29-31 BERRY AVENUE

29 Berry Avenue

This is in reference to your application for a building permit for a new deck at 29 Berry Avenue in the R-3 Residence Zone. We will need a more detailed plot plan than the one which was submitted at the time the application for a building permit was filed in this office.

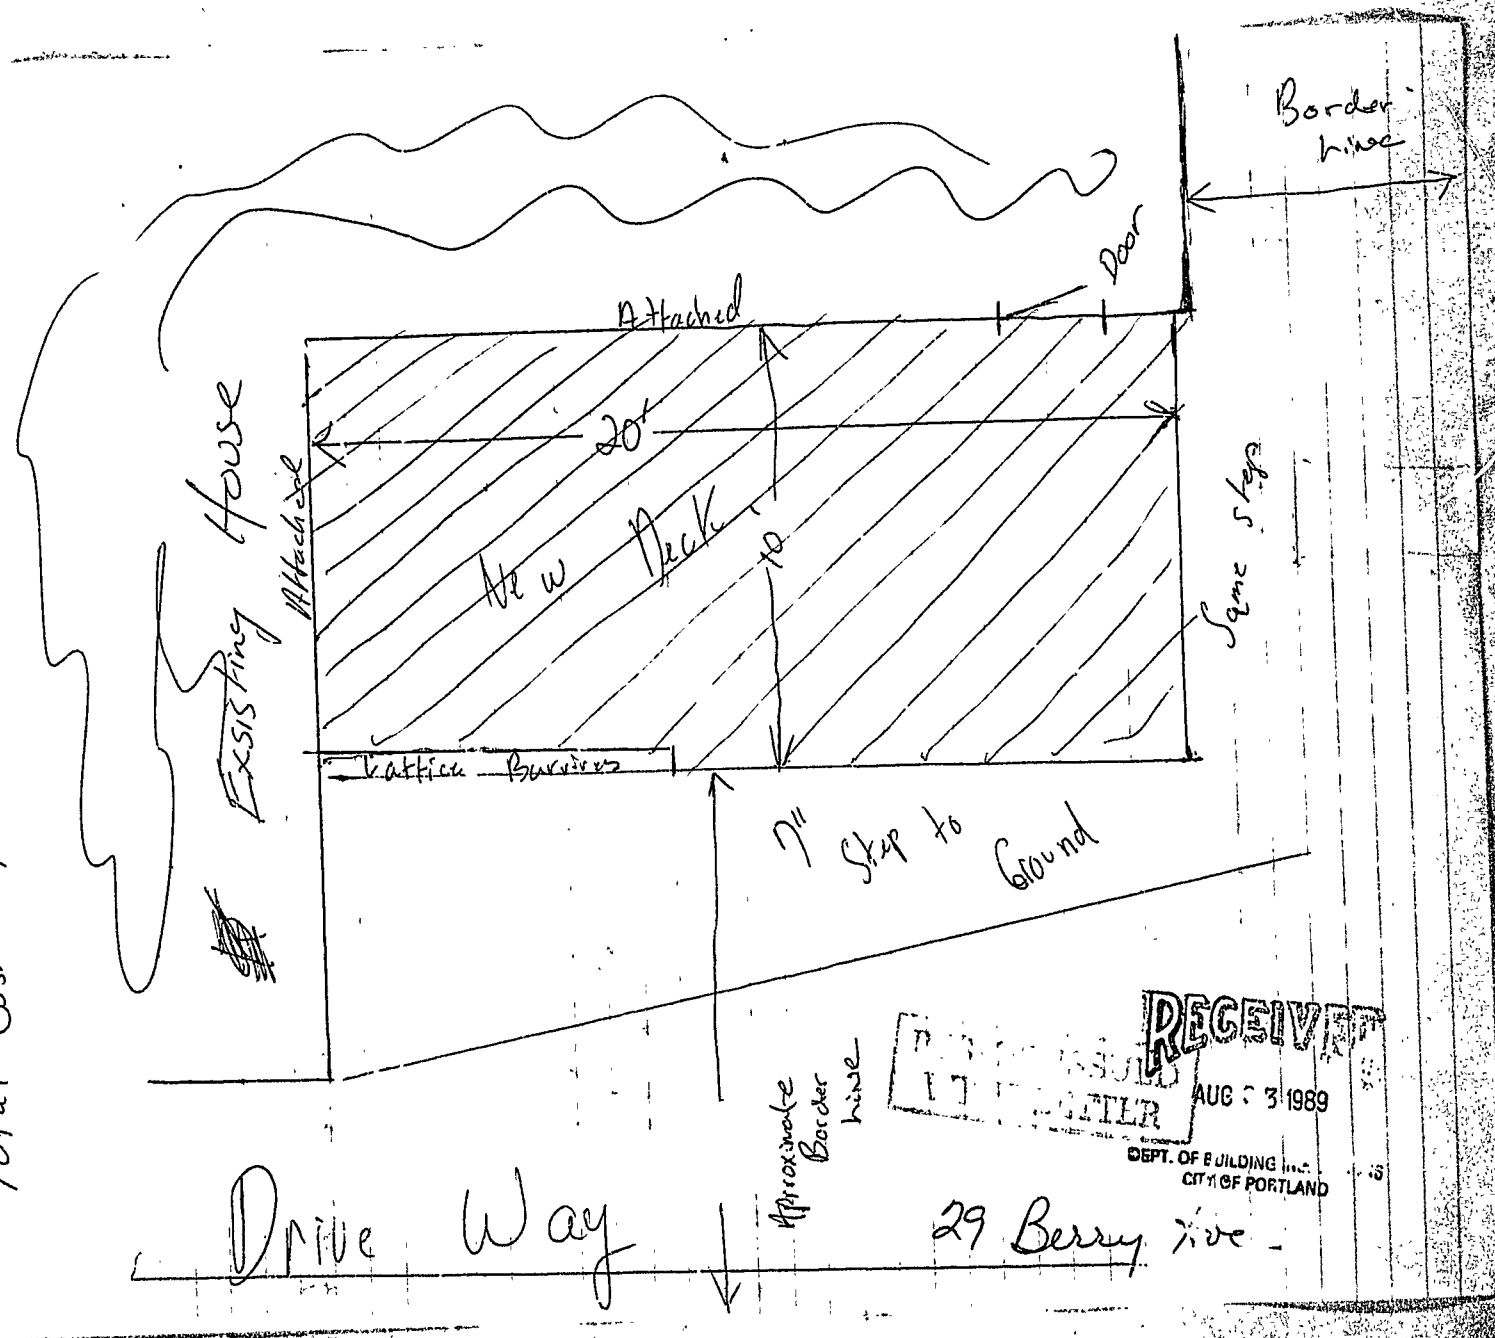
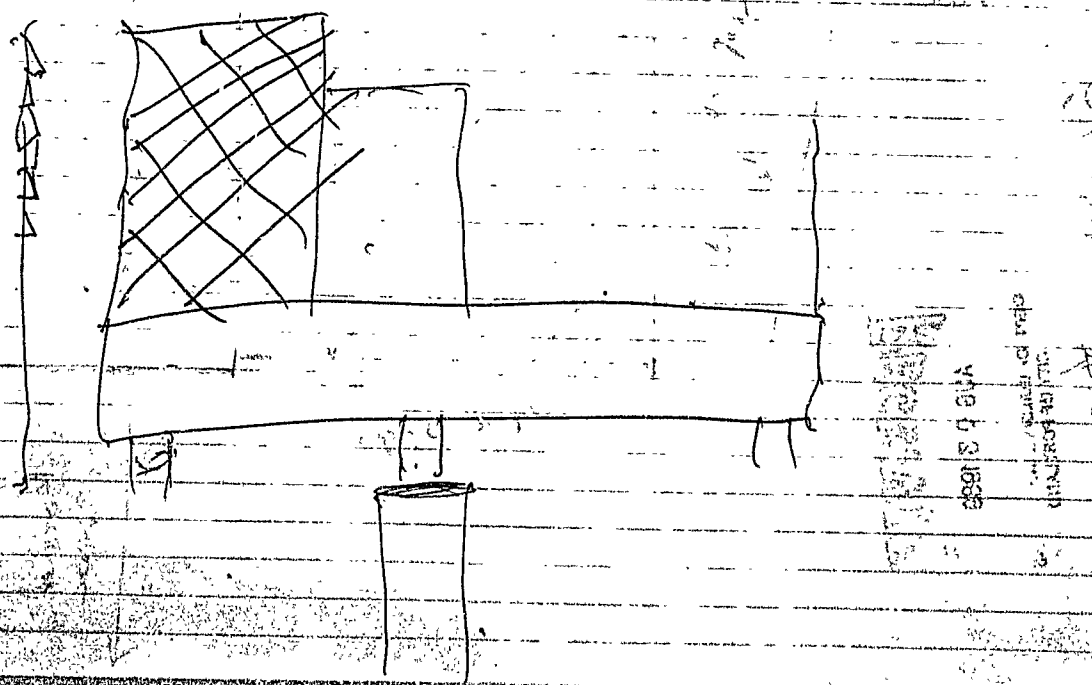
Please show the exact dimensions for setbacks from the proposed deck to the front, side and rear property lines and revise the plot plan to show these dimensions from the proposed deck to the lot lines.
